**SUPPLEMENTAL/BID BULLETIN NO. 1**  
(October 29, 2021)

**(Procurement of Supply and Delivery of ICT Equipment, Services, and Software for NCIP Communication Center)**

# NCIP Communication Center (Layout Plans)

## Video Wall Arrangement

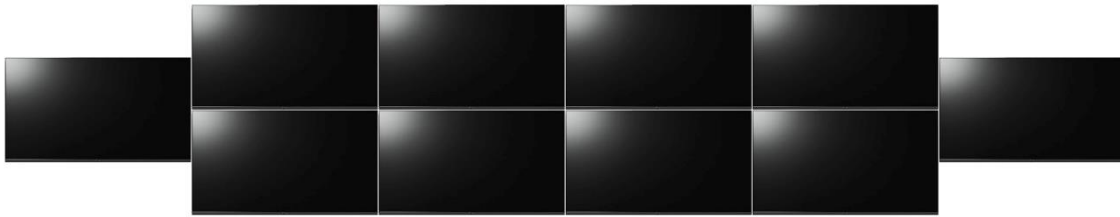
Floor plan (Lay out) of the videowall	Please refer to the attached NCIP Communication Layout Plans.
What does 1 set Stereo Sound System include?	It includes 1 set of active speakers (left and right channels) that has a built-in amplifier. FM function is now optional.
<b>LOT 3 concerns</b>	
<b>CCTV</b> • HD 16 CH 1080P DVR	This specification is now amended as: “HD 16 CH 1080P DVR or better.” All other specifications under CCTV remain.
<b>OTHER CONCERNS raised</b>	
Per lot basis?	Yes, the submission of bids is per lot basis but the whole bidding is conducted at one time. Bidders may submit bid/s for lot 1 or lot 2 or lot 3 or for all of the lots.
Can a bidder submit supporting documents like single largest contract for delivery of ICT equipment or supplies to bolster its bid for Lot 1 (delivery of system)?	NO. All supporting documents like single largest contracts for Lot 1, or Lot 2, or Lot 3 should be related to or similar to that being offered a proposal.  Supporting documents for hardware should not be submitted to support bid for software.

- Monitor size 65 inches
